# Memorandum

**Subject:** Ordinance Revising Zoning and other Land Development Regulations Pertaining  
to the Downtown Kendall Urban Center District

ORDINANCE REVISING ZONING AND OTHER LAND DEVELOPMENT REGULATIONS PERTAINING TO THE DOWNTOWN KENDALL URBAN CENTER ZONING DISTRICT ("DKUCD"), AMENDING SECTIONS 33-284.56 THROUGH 33-284.63, CODE OF MIAMI-DADE COUNTY, FLORIDA, PROVIDING SEVERABILITY, INCLUSION IN THE CODE AND AN EFFECTIVE DATE

Sec. 33-284.61. Regulating Plans.  
A. Sub-District Plan

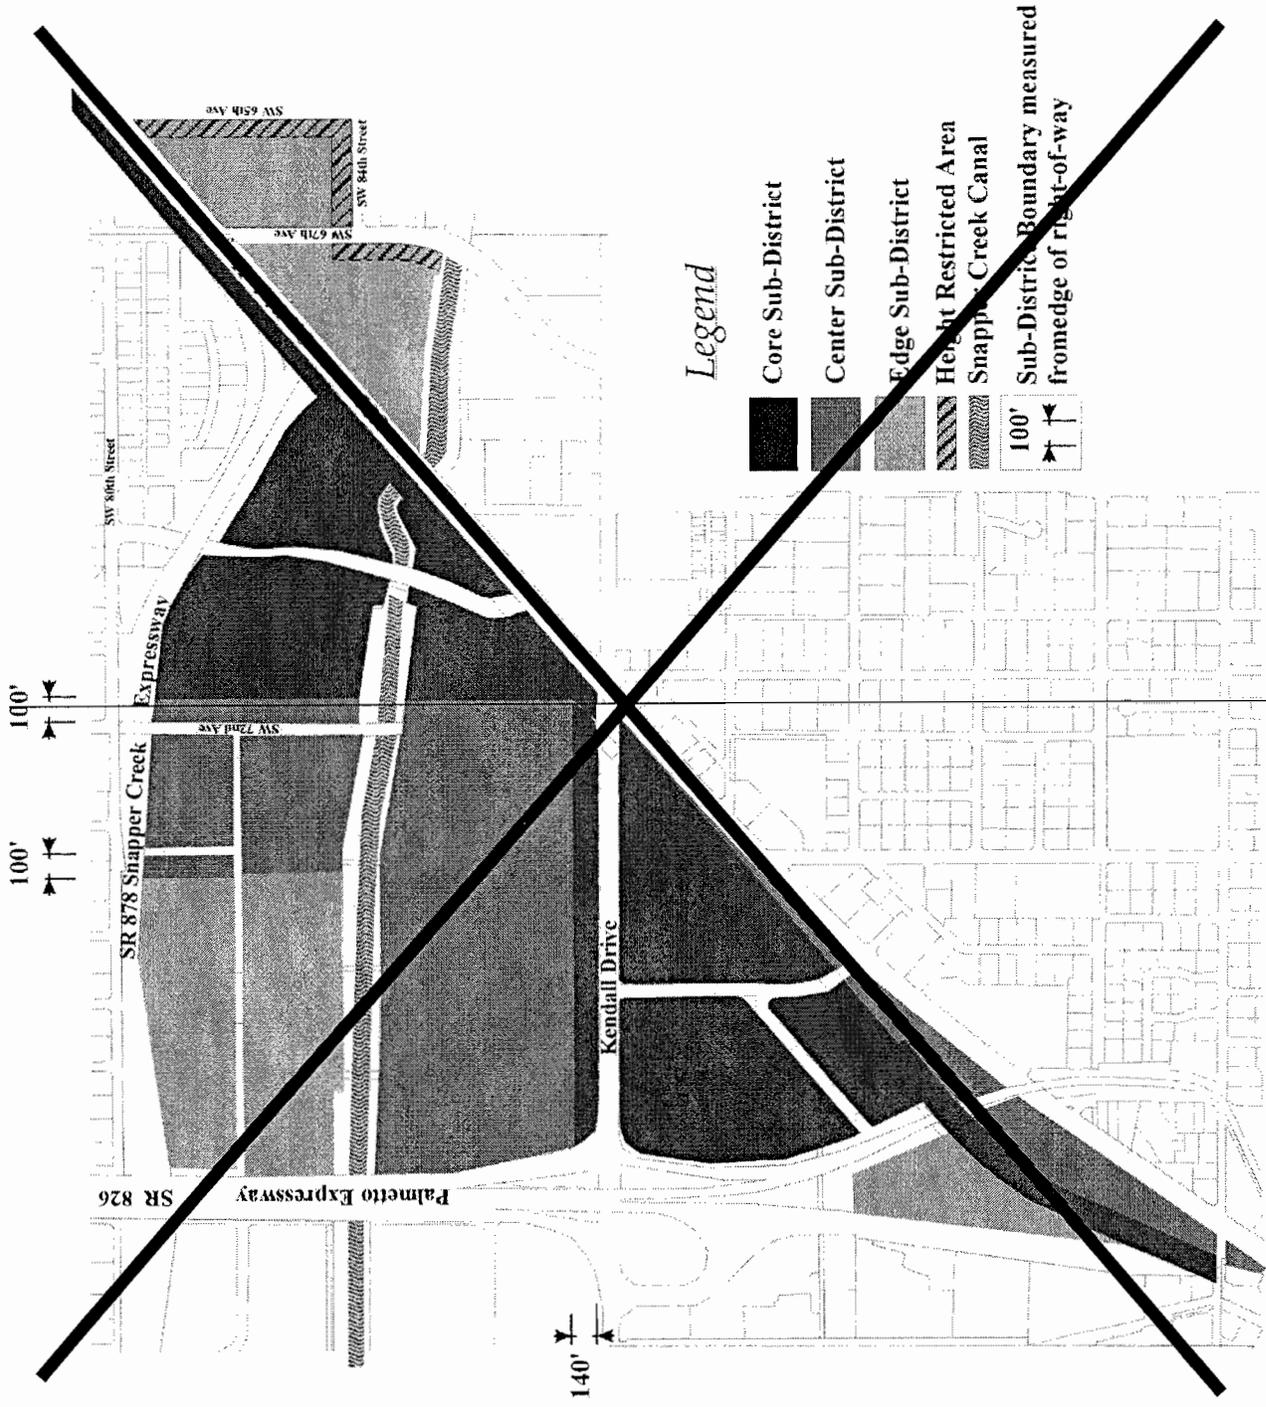
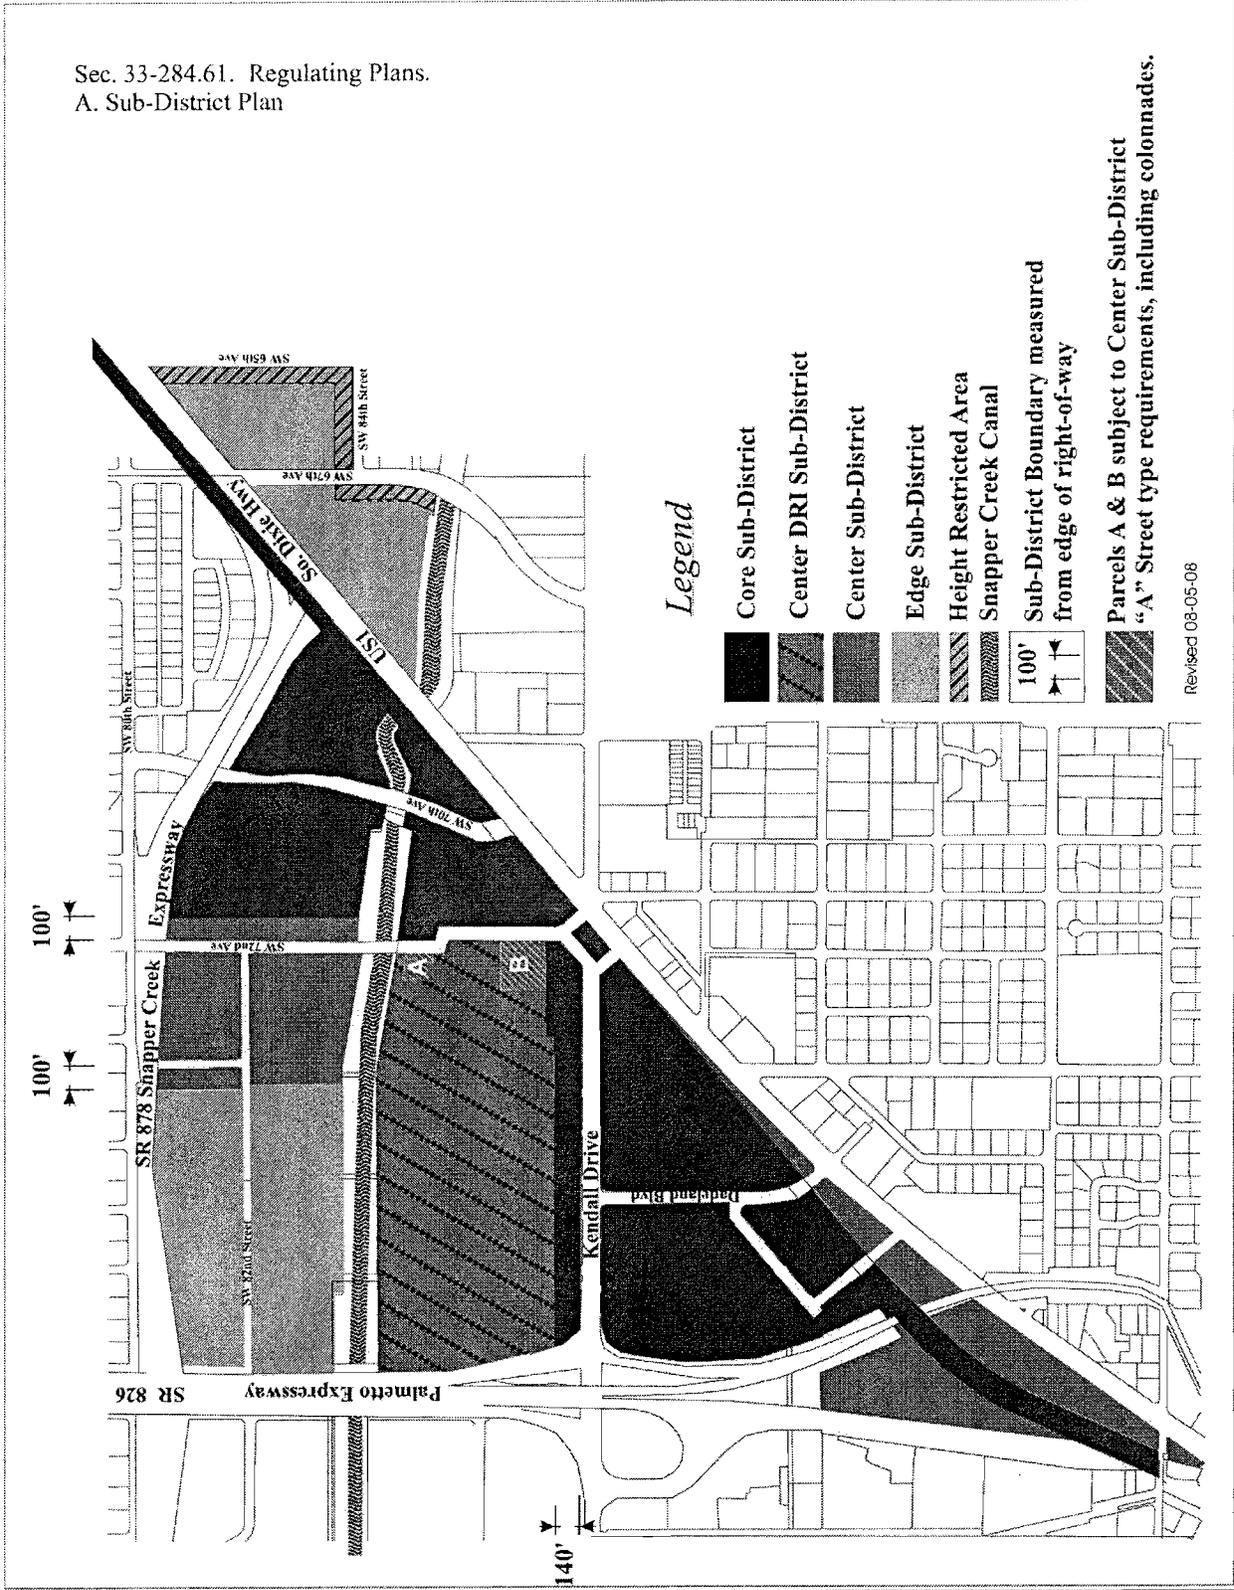
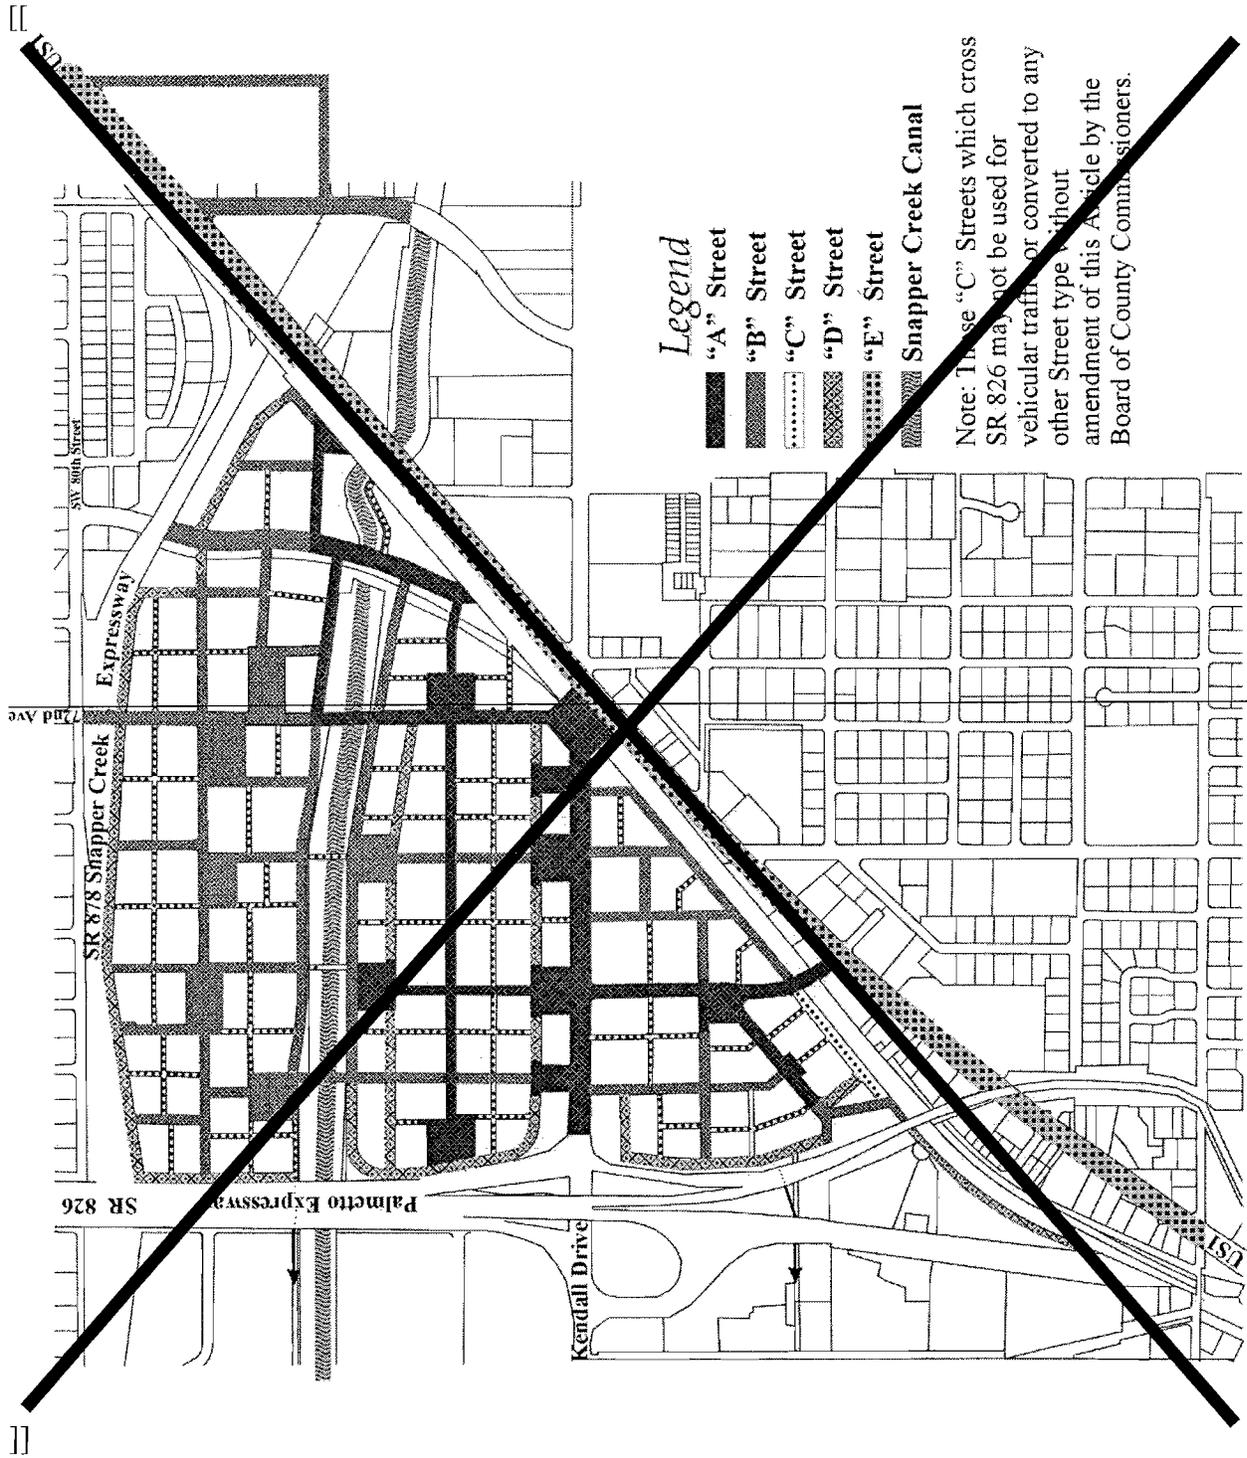
Section 3 of this ordinance revises the Regulating Plans section in order to provide for changes resulting from the administrative site plan review approval process for projects in the area.

Core Sub-District – “A” Street

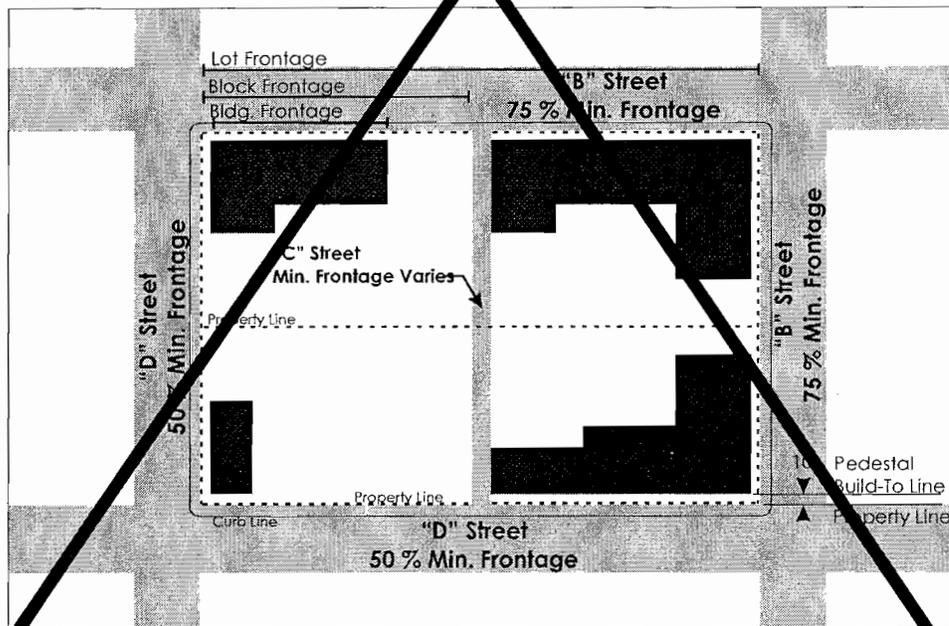
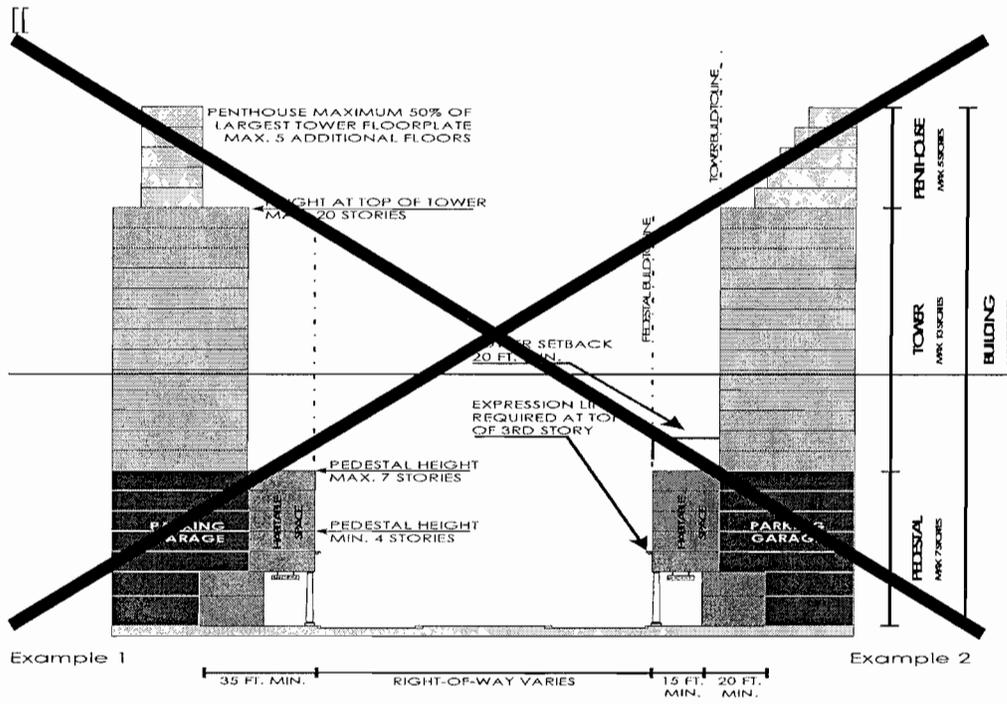
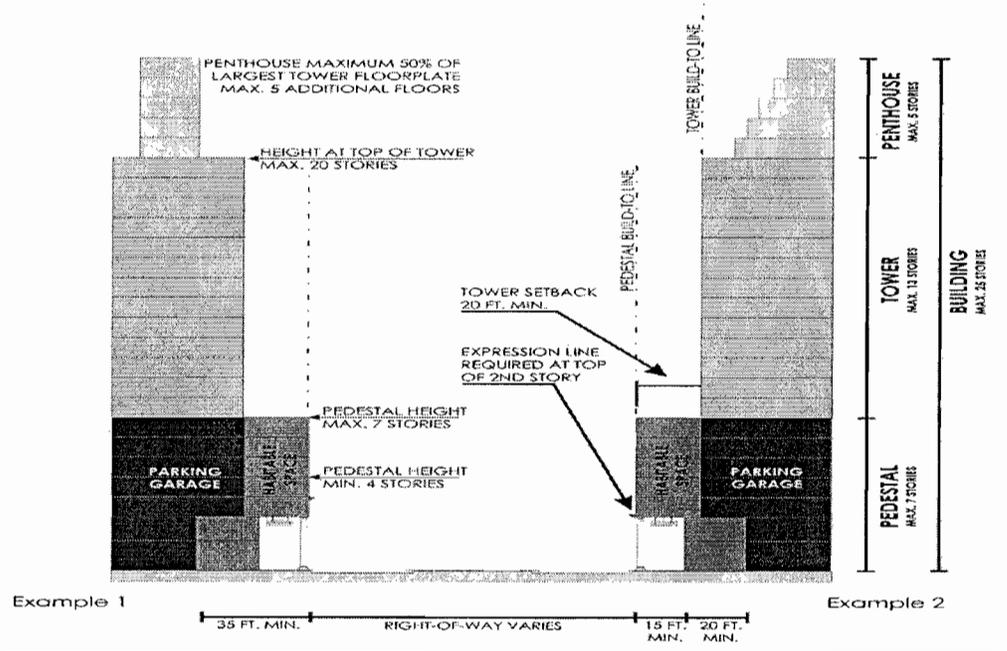
**Interior Side/Rear** – Zero (0) foot ~~setback~~ >>minimum<< setback for pedestal ~~setback for~~ tower and penthouse.

**Expression Line** – Required at the top of the ~~[[third]]~~ >>second<< story.

**Core Sub-District – “D” Street**

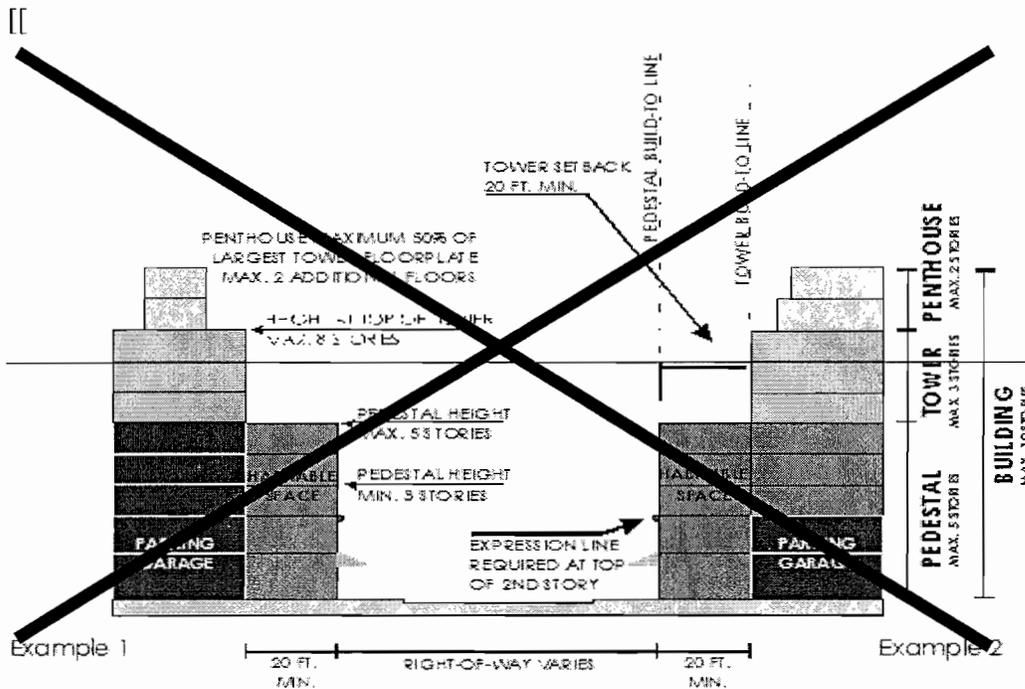
**Interior Side/Rear** – Zero (0) foot >>minimum<< setback for pedestal>>,<< ~~[[thirty (30) foot minimum setback for]]~~ tower and penthouse.

**Center Sub-District – “A” Street**

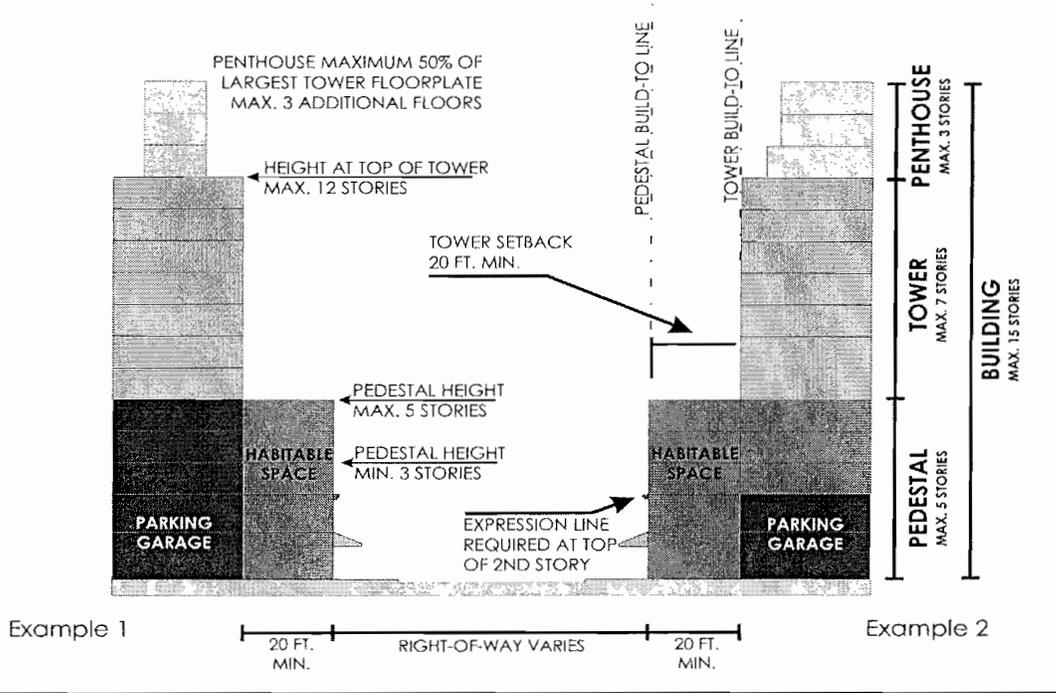
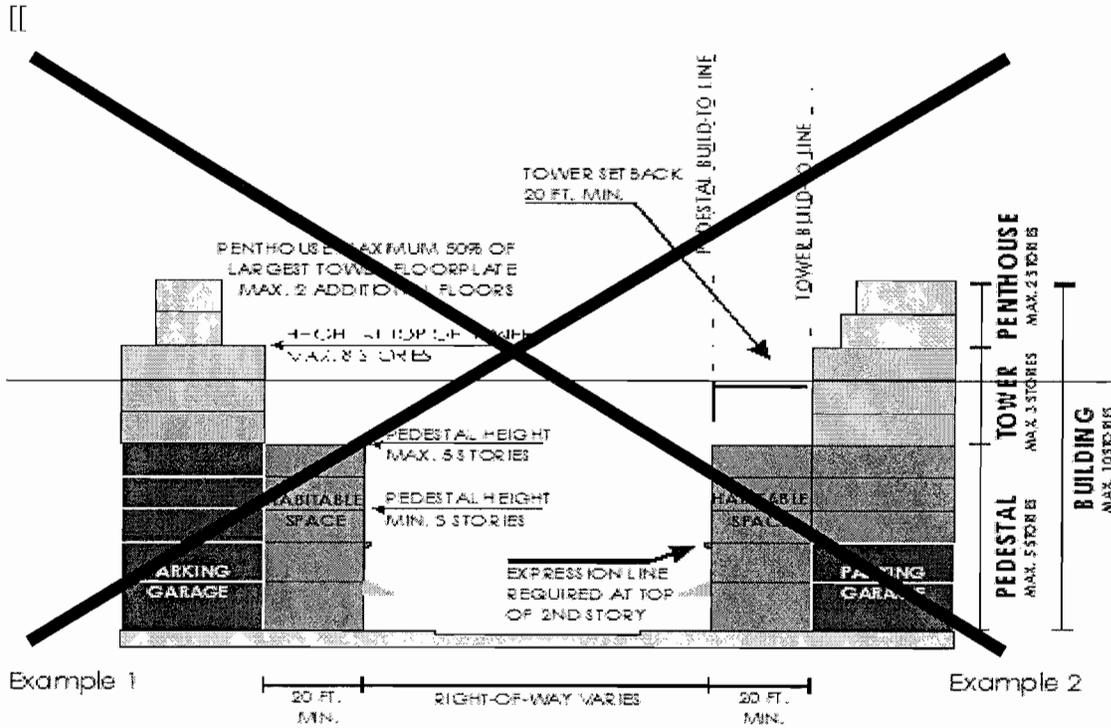
**Pedestal** – At street front three (3) stories minimum / five (5) stories maximum.  
**Tower** – ~~[[Three (3)]]~~ >> Seven (7) << stories maximum.  
**Penthouse** – ~~[[Two (2)]]~~ >> Three (3) << stories maximum. Floorplate maximum is fifty (50) percent of largest tower floorplate below.

**Expression Line** – Required at the top of the ~~third~~ >>second<< story.
